HISTORIC PRESERVATION BOARD

HISTORIC PRESERVATION BOARD MEETING

WORKSHOP
40-46 FREE STREET

TO: Chair Sheridan and Members of the Historic Preservation Board
FROM: Deb Andrews, Historic Preservation Program Manager
DATE: April 24, 2019
RE: May 1, 2019 WORKSHOP – Preliminary Review of Proposed Mixed-Use Construction

SHEET TITLE:
EXTERIOR
ELEVATIONS

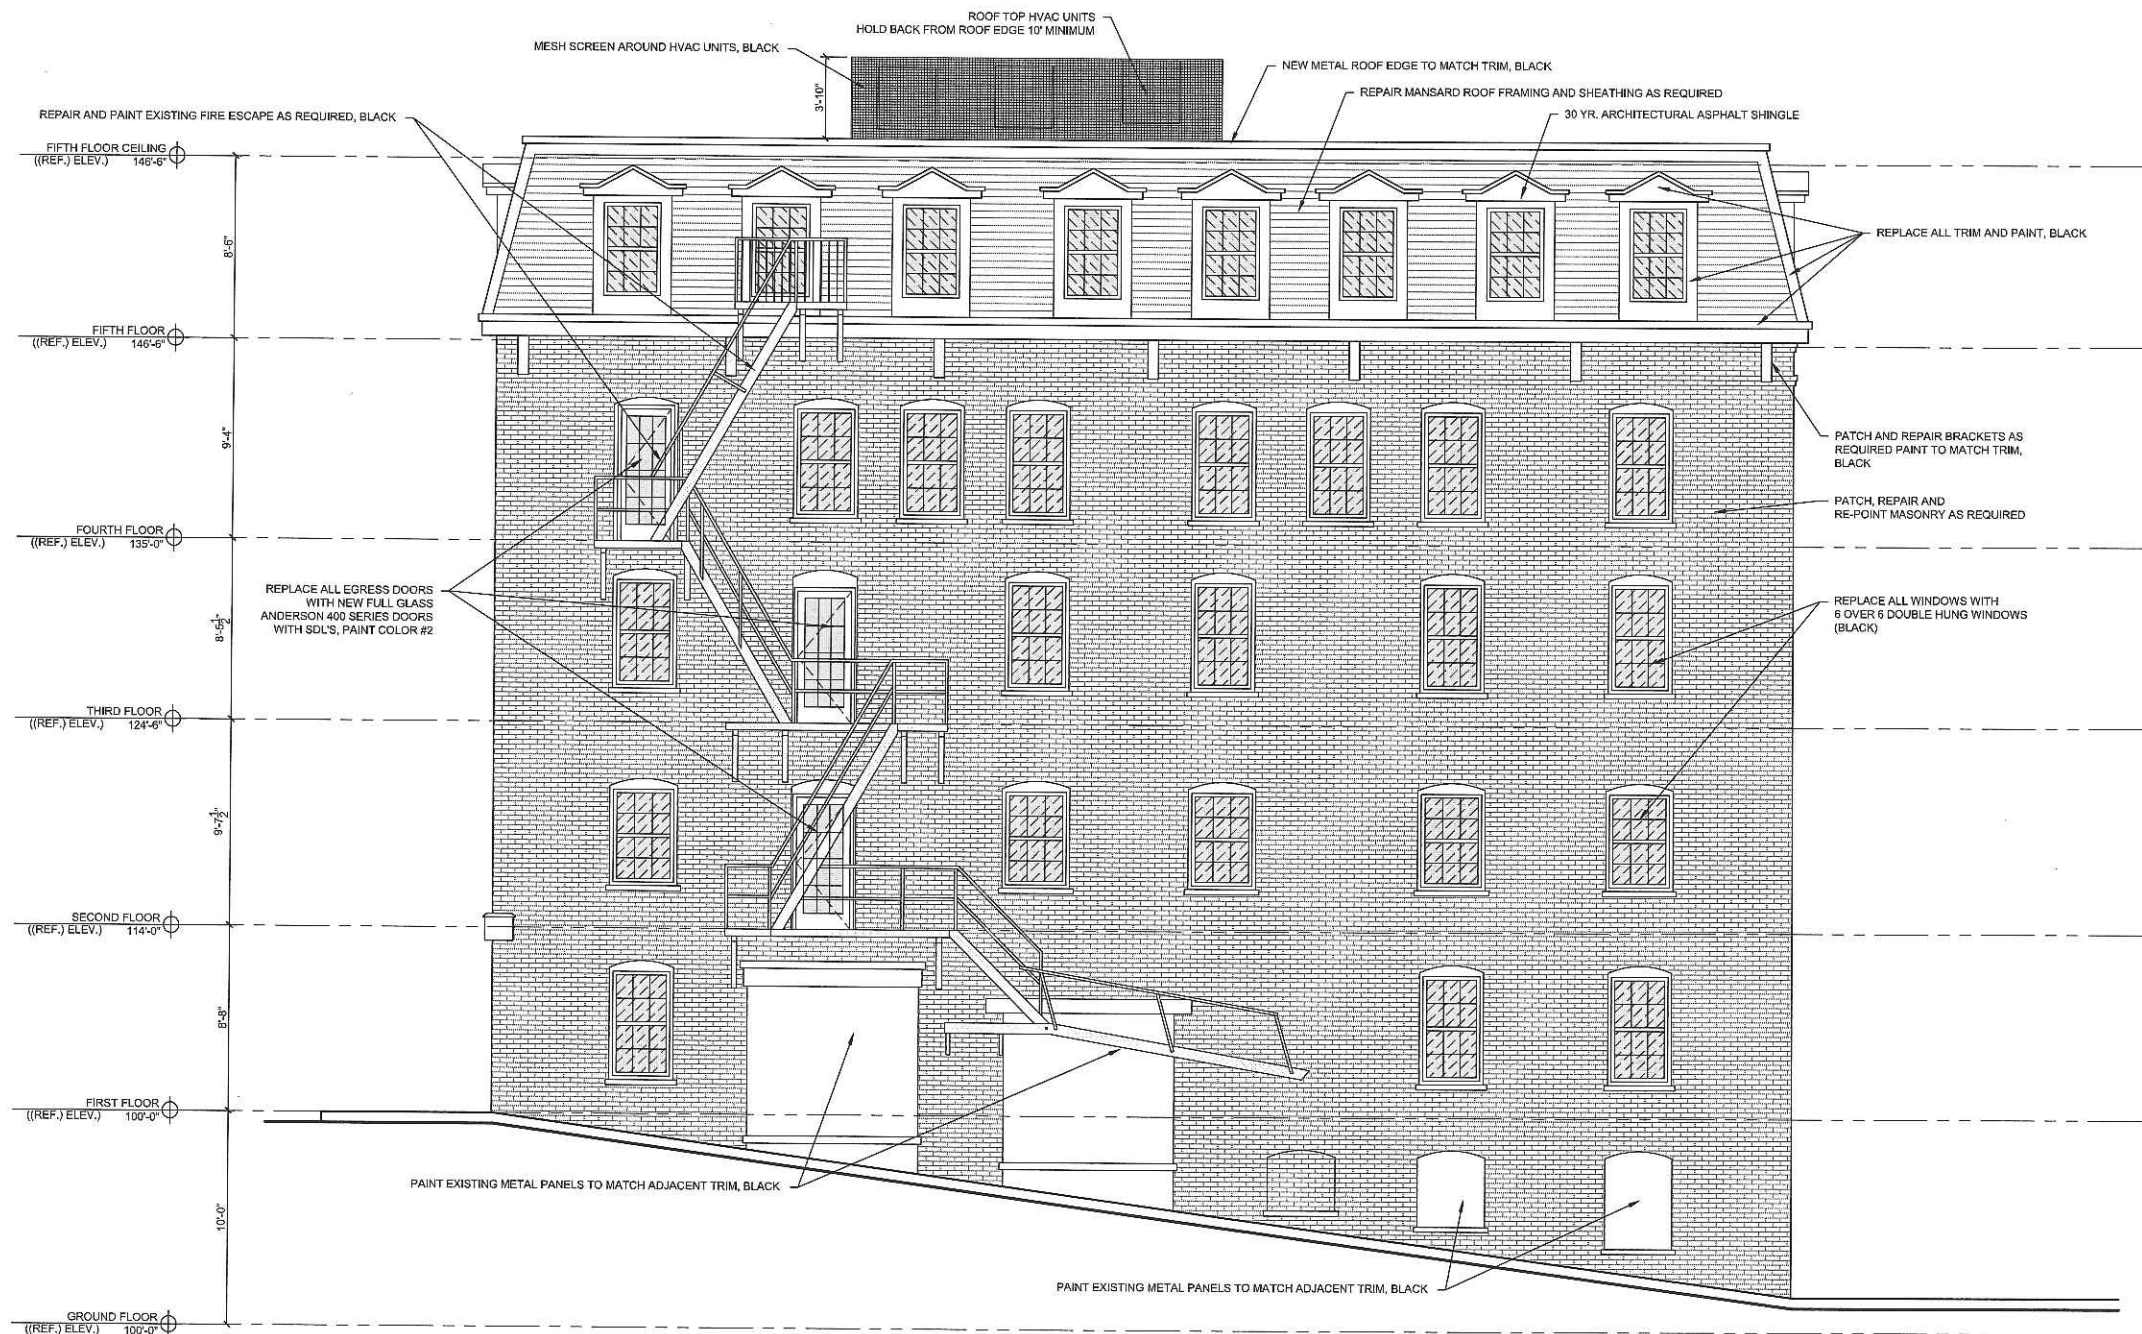
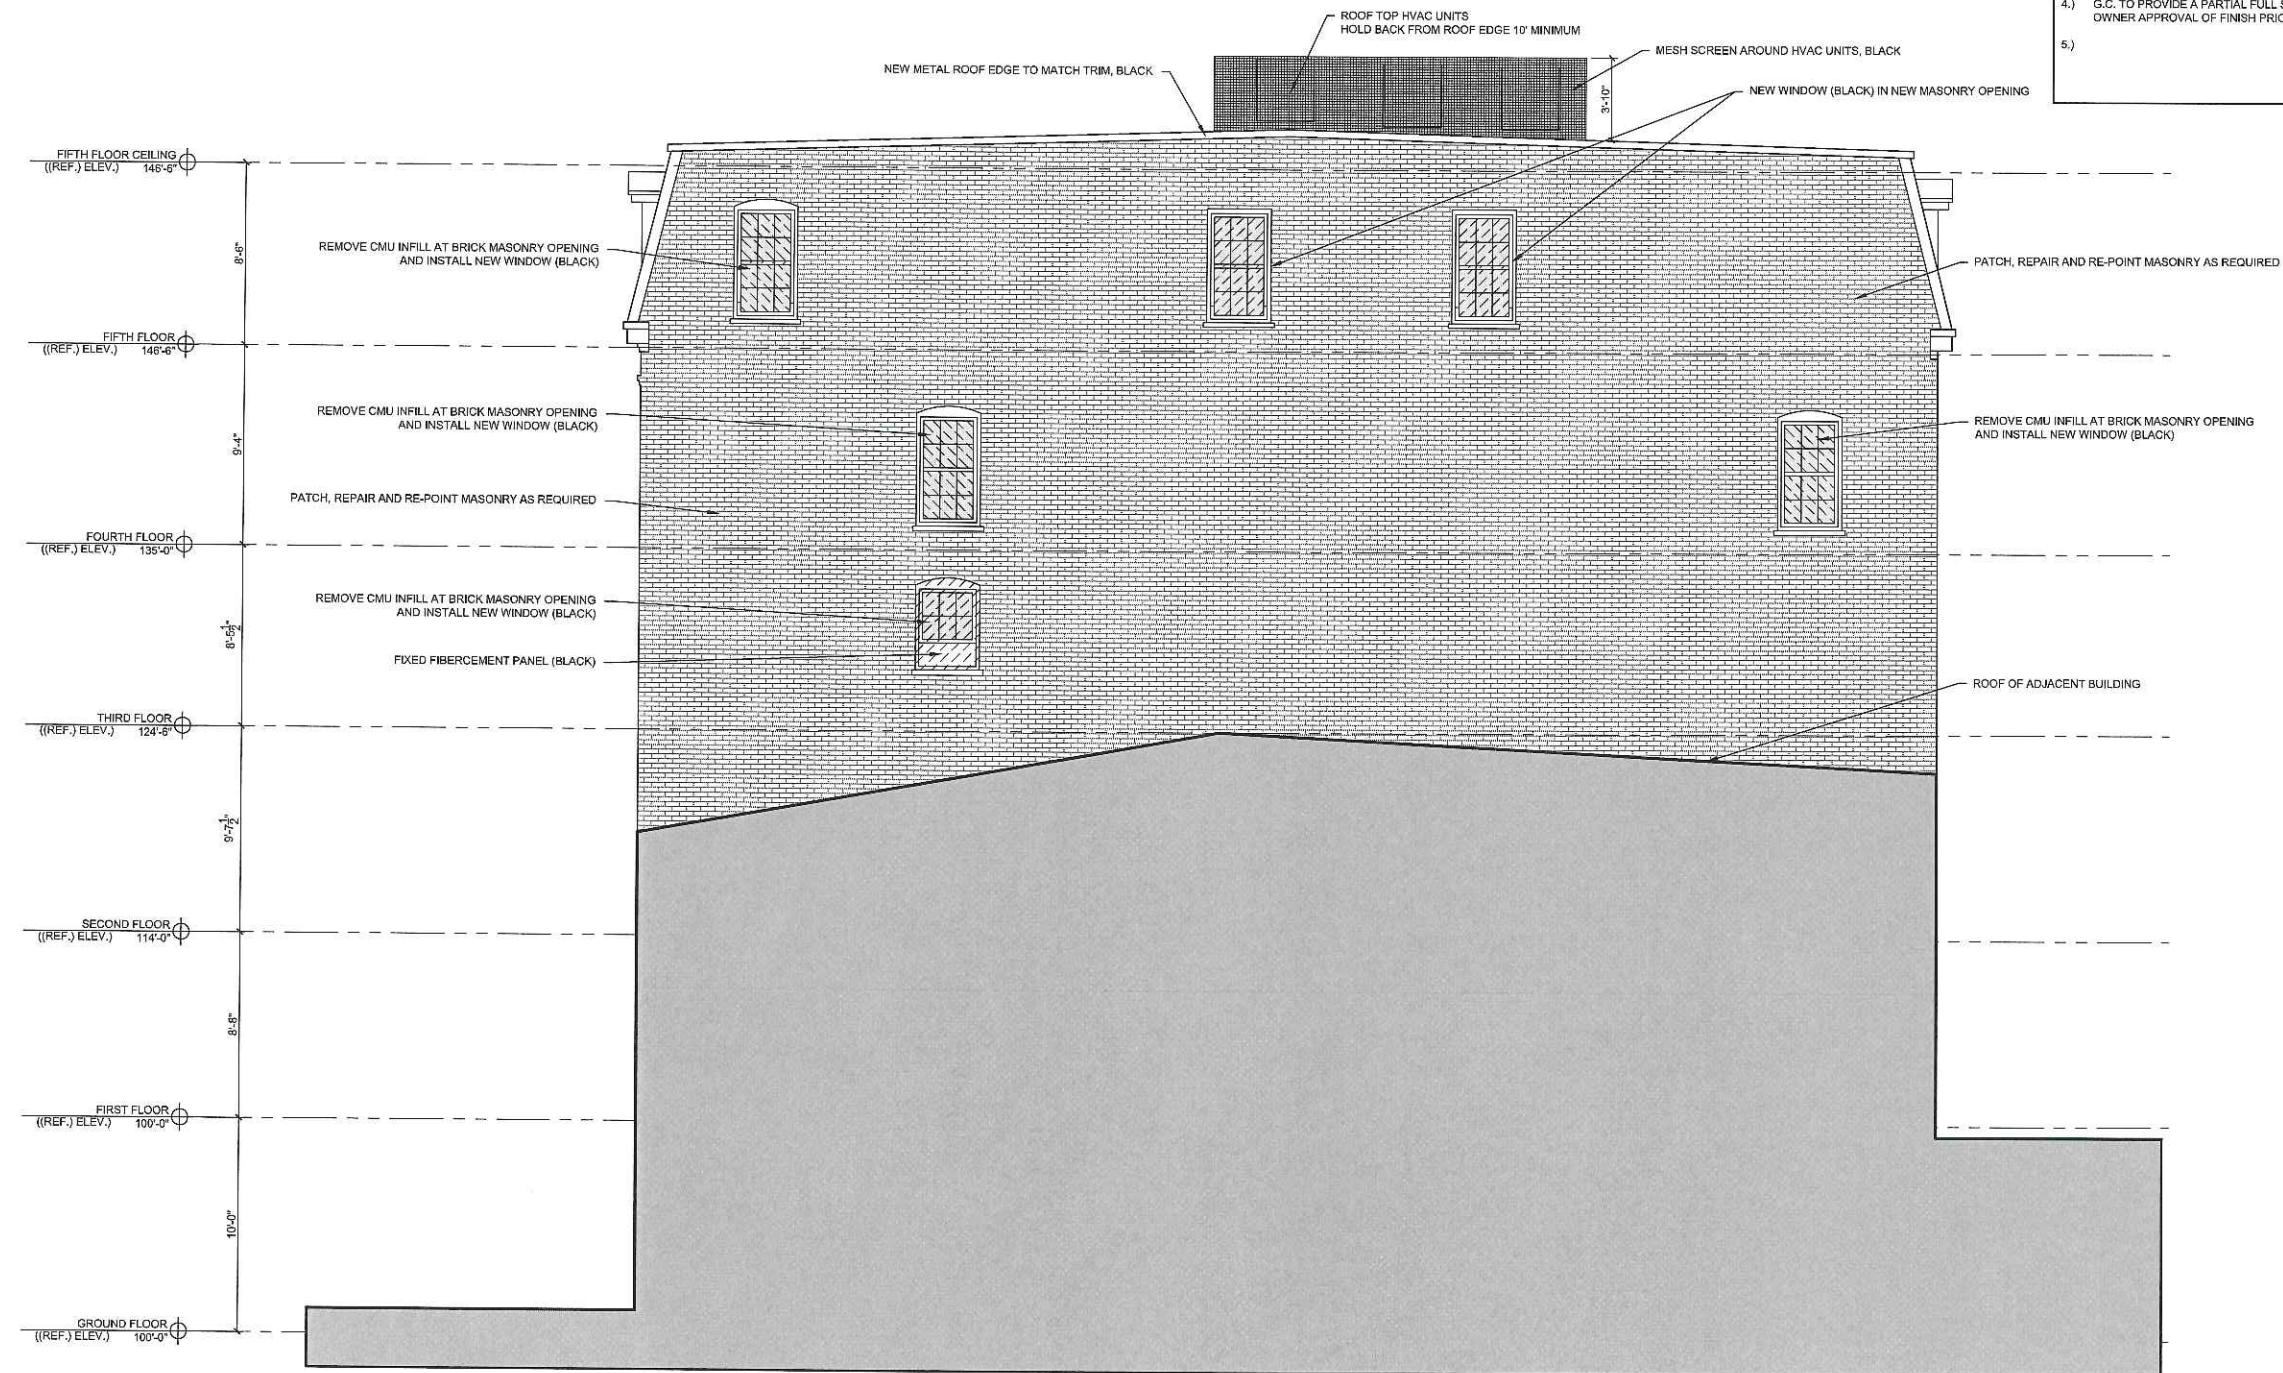
If the details of the windows are carefully specified they will be a big improvement over the existing aluminum ones; staff believes that especially since they are not replacing original historic windows (which are gone,) high quality clad units that match the historic appearance can be approved in a downtown commercial setting. It appears that painted wood brick mould still exists at the edges of the masonry openings. Staff recommends requiring that trim this be retained, and repaired or replicated as needed.

The slate on the north (front) mansard appears to be in poor condition, but staff believes it would be an unfortunate loss to lose this reminder of the historic material. It may be that the tax credit reviewers will take the same view. For the mansards that are already asphalt, staff suggests that a slate substitute such as a Slateline asphalt shingle might be more appropriate than architectural shingles.
